Recommended Changes to be Adopted with the Peery Park Specific Plan

Staff Recommended Changes to the Peery Park Specific Plan Document				
	Current PPSP Section	Current Provision w/ Changes	Proposed PPSP Section	Notes to Describe Change(s)
1	2.2.1.B.2. Page 49	<u>Residential development projects</u> in the Neighborhood Transition district shall.....pertaining to the <u>processes, procedures and development standards</u> pertaining to the Medium Density Residential (R-3) zoning district with the following <u>two</u> exceptions.....	Same	Clarification of intent
2	2.2.1.B.2.b. Page 49	<u>Residential Development</u> shall conform to Section 2.2.2. <u>C.1.a</u>	Same	Clarification of intent
3	Table 2.1 Page 53	S1: Permitted on upper.....District Activity Center requirement is met <u>in conjunction with the Activity Center use of the site. May not apply to the Activity Center overlay when parcels are used for industrial/office/R&D uses</u>	Same	Office/Industrial and other similar uses are allowed on the ground floor in the Activity Center overlay or in the Activity Center if not used in the District Activity Center manner. Clarification needed

1. Updated Fig. 4.3.3.A & B Bicycle & Pedes

FIG. 4.3.3.A BICYCLE NETWORK IMPROVEMENTS

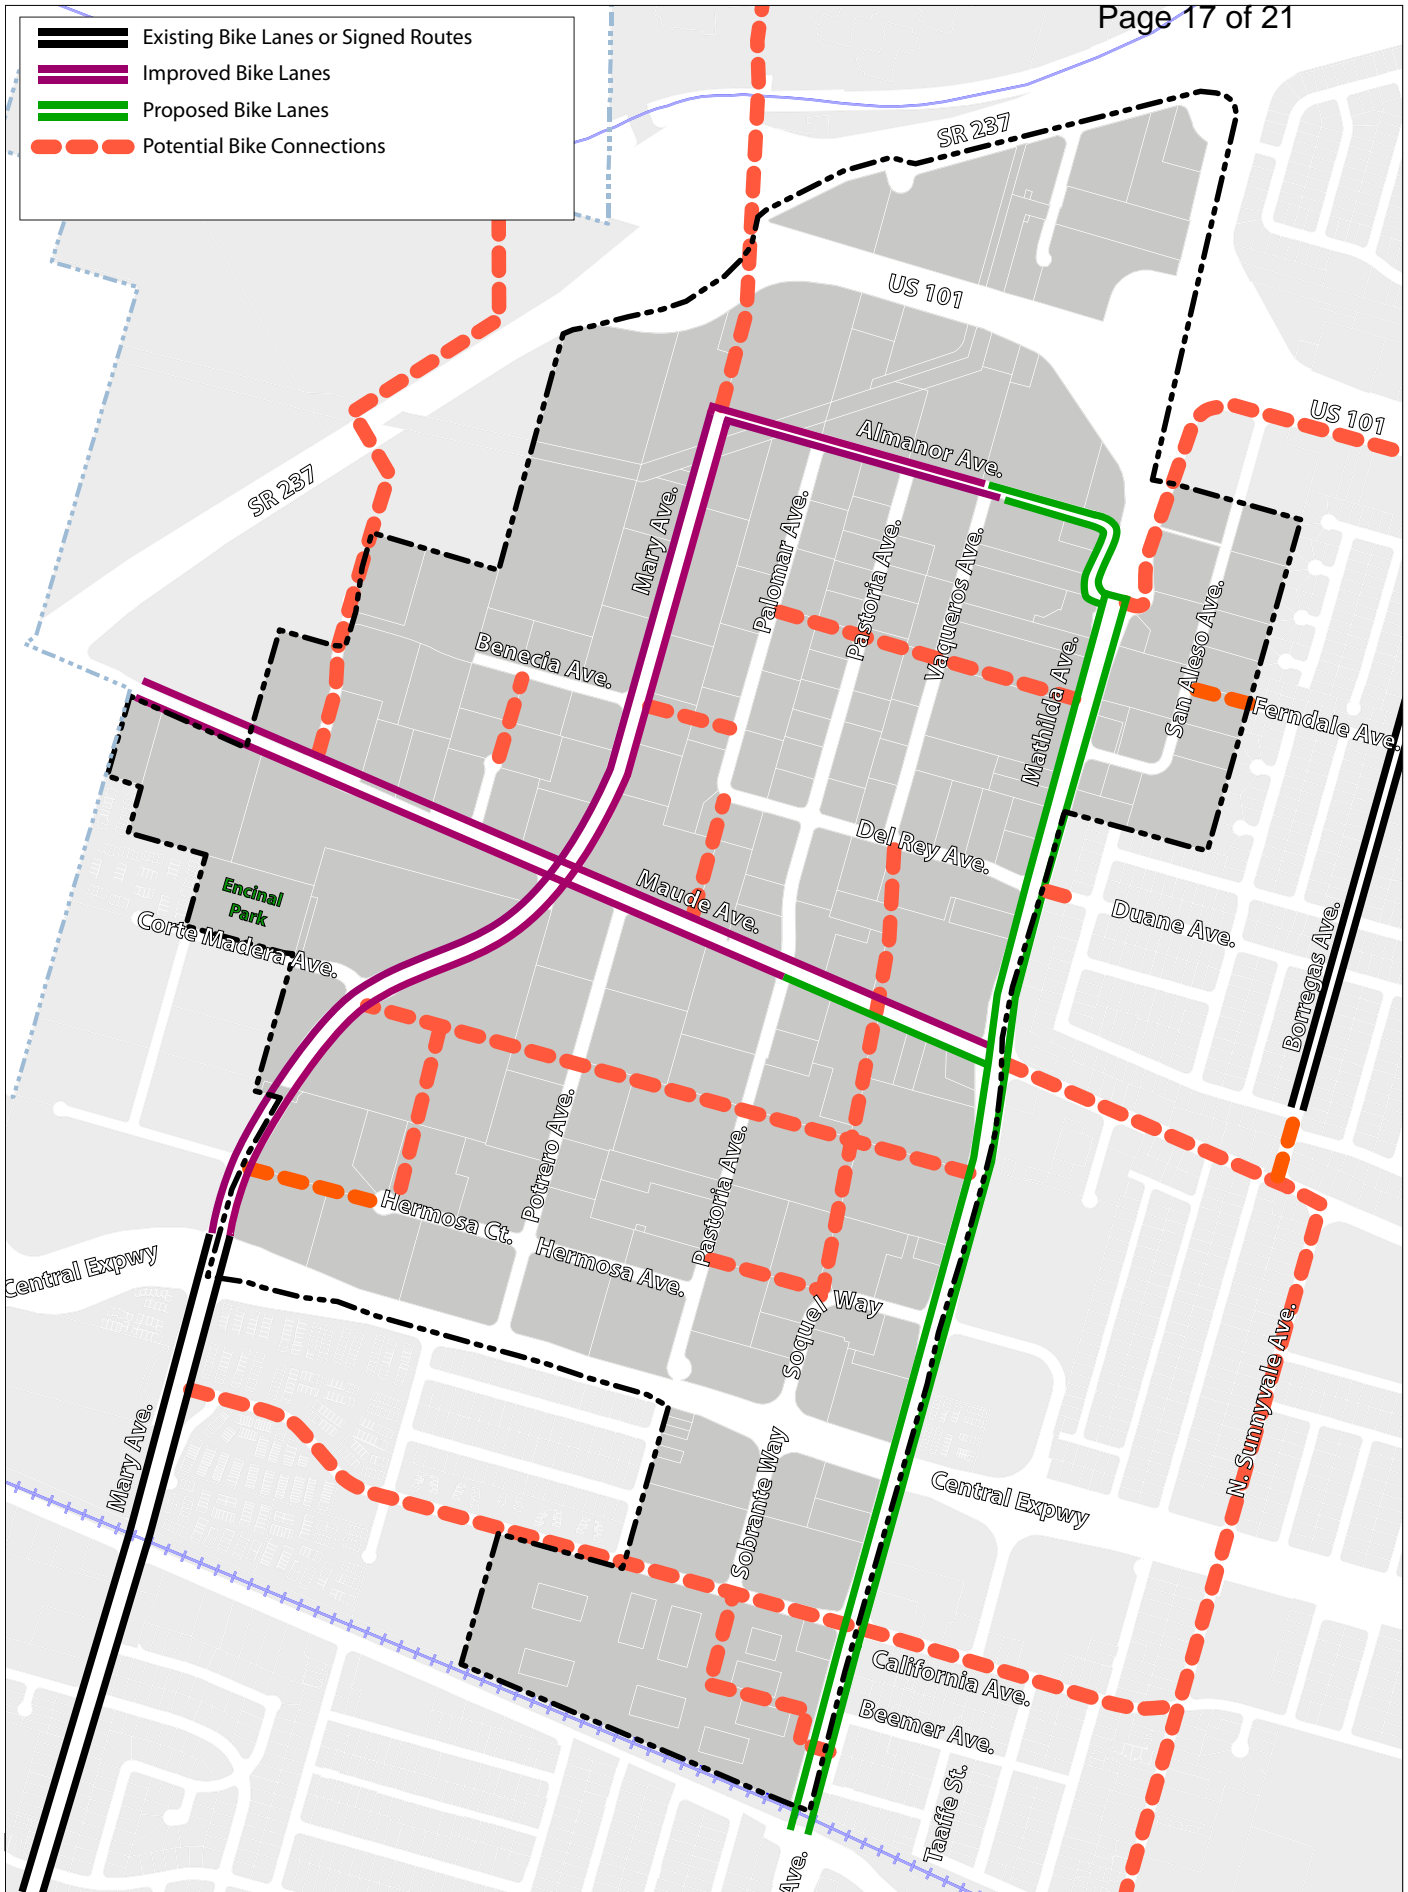
18	4.3.3.B Page 136	Add additional potential pedestrian connections throughout the district. Shown in Attachment 1 of this document.	Same	More public pedestrian connections through the district will help to make the district more vibrant and active and will help to accomplish many of the PPSP objectives.
19	4.6 Page 140	<i>Shuttle (or bus) Stops:</i> Improvements include bus shelter, site improvements and construction at transit stops of the future Peery Park Rides service area and other potential Peery Park shuttles	Same	The intention was these stops could be for Peery Park Rides or for a future shuttle program for the district.
